# **Staff Report**

#### **Knoxville Historic Zoning Commission**

File Number: 10-B-25-HZ

Level III Construction of New Primary Building

1 FRONT ELEVATION A201 3/16" = 1'-0"

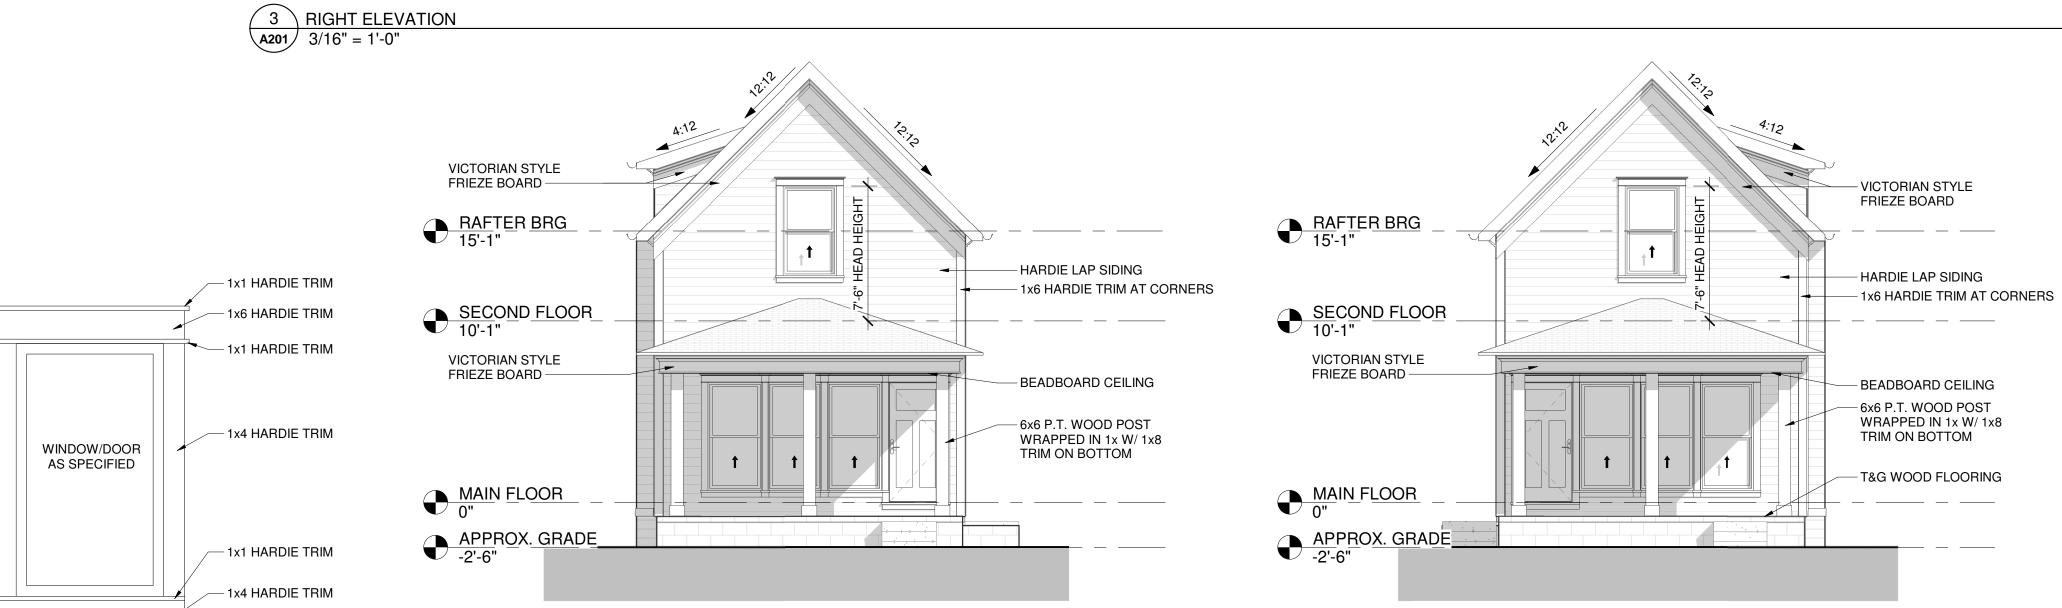
- 6. Guidelines recommend "avoid[ing] new construction that varies in height, so that new buildings are equal to the average height of existing buildings." The block only features one-story houses, so the duplex would be the only two-story building on the block. However, the lot is adjacent to the Olde Mechanicsville Park and is in clear view of two-story buildings on Arthur Avenue that are larger in scale, and the second-story employs a vaulted ceiling to allow for a 5' tall floor, making it shorter than a typical two-story building. In the opinion of staff, the two-story height is appropriate for the context. The 2'-6" tall foundation is similar in height to the other houses on the block. Guidelines recommend that "beltcourses or other suggestions of between stories that suggest the beginnings of additional stories shall be used" on new construction, and such an element is not present in the design. The Board should discuss the height of the proposed duplex and whether details indicating the separate stories should be introduced.

- 9. The proposed 12/12 pitch front-gable roof clad in architectural shingles meets design guidelines for pitch and materials, and it benefits from the eave overhangs and frieze board molding. However, additional architectural elements could be added to the façade roofline to reflect the context.

- 7) additional architectural detail to reflect the context be added to the façade, to be approved by staff;
- 8) final window and door selections to be sent to staff for approval; and

4 LEFT ELEVATION A201 3/16" = 1'-0"

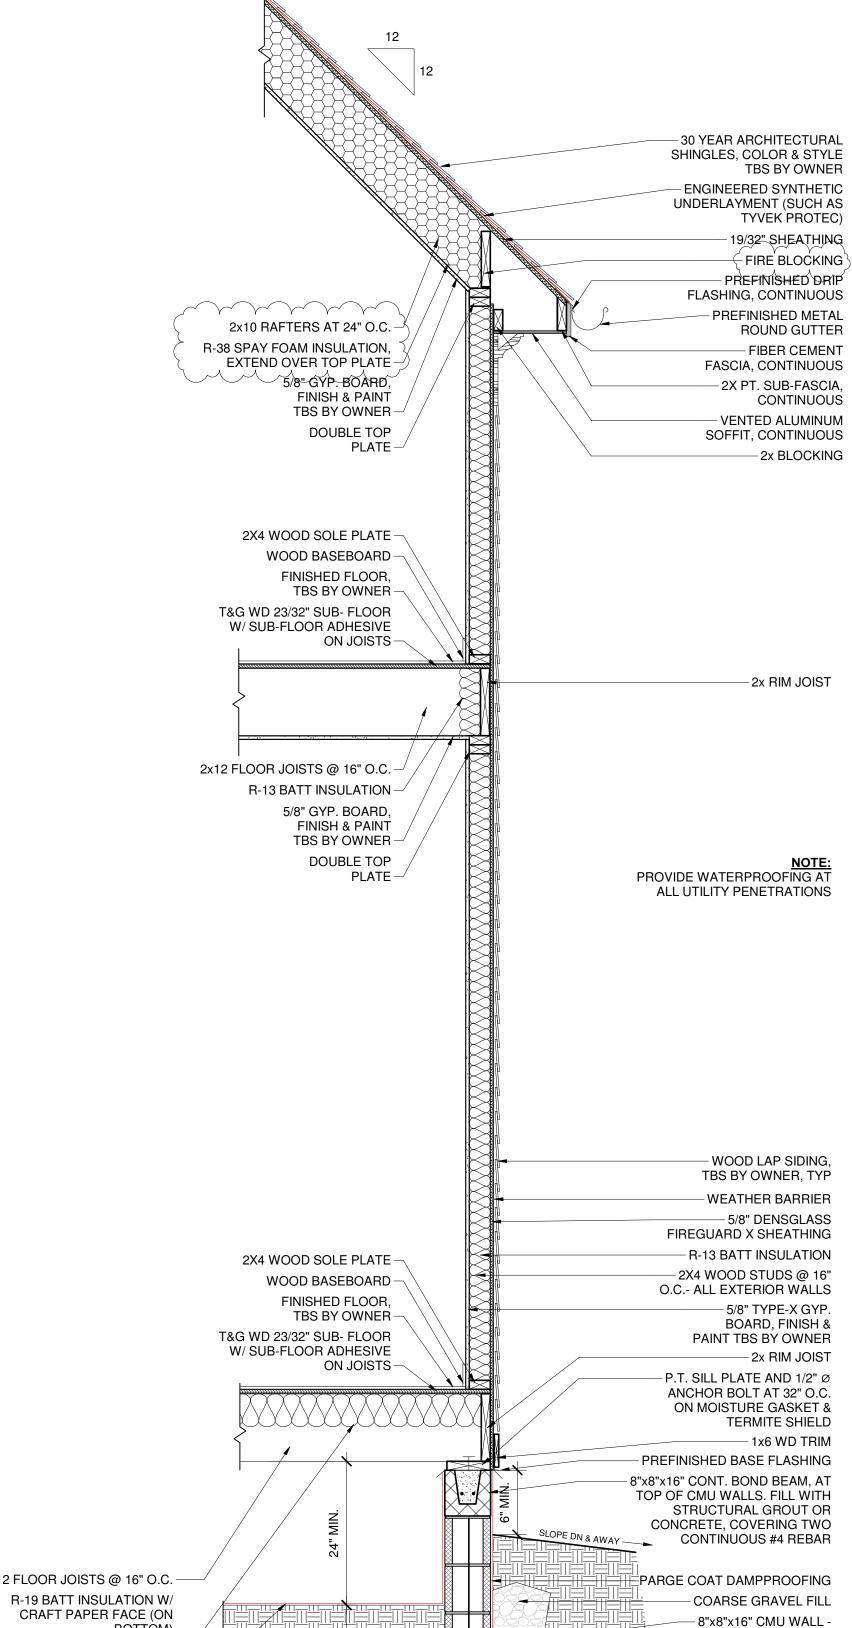
- 4. The duplex is proposed to be centered between the side lot lines with a 4' side setback on the right (east) elevation and a 3' side setback on the left (west) elevation, as the faux chimney is not a permitted encroachment. The Middle Housing standards allow Planning staff to administratively approve a variation for the proposed 4' side setbacks during permitting, with the support of City Engineering, but the 3' side setback on the left (west) elevation would require a variance from the Board of Zoning Appeals or the Historic Zoning Commission (Article 4.6.G.1.a.ii, Article 8.5.C, Article 16.3). The HZC has the authority to issue variances to dimensional standards via COA if alternative standards are specifically recommended in the design guidelines.

However, in the opinion of staff, it is not appropriate to issue a variance for a 3' side setback to allow for the faux chimney on the highly-visible left (west) elevation, as that feature does not approximate historic chimneys and is thus not supported by the design guidelines. This is further discussed in comment 7. The Commission should discuss whether approval of the variance for the 4' side setbacks should be delegated to Planning staff during permitting or approved by the HZC via COA.

The proposed faux chimney should be removed. The other shotgun houses on the block, which have a similar depth, feature some side elevations without a projecting feature. The shed roof massing sufficiently breaks up the side elevation to meet the recommendations of the design guidelines but does not fulfill Article 4.6.E.4.b. The HZC should discuss whether the proposed structure is consistent with the design guidelines and the neighborhood context without a recess or projection on the left (west) elevation.

If the Commission deems that an alternative feature should be present on the left (west) elevation to meet Middle Housing standards, such as making the shed roof massing a two-story projection, a variance for a 3' side setback via COA could be appropriate, and the requested feature should be identified in a condition.

- 3) front setback to meet Middle Housing standards, with final approval by staff;
- 4) removal of the faux chimney on the left (west) elevation, encouraging Planning staff to approve a variation from Article 4.6.E.b. on the left (west) elevation during permitting;

- 5) granting variances for a 4' side setbacks, contingent on meeting condition 4 and any applicable building code requirements;
- 6) the porch supports to be at least 8" by 8";
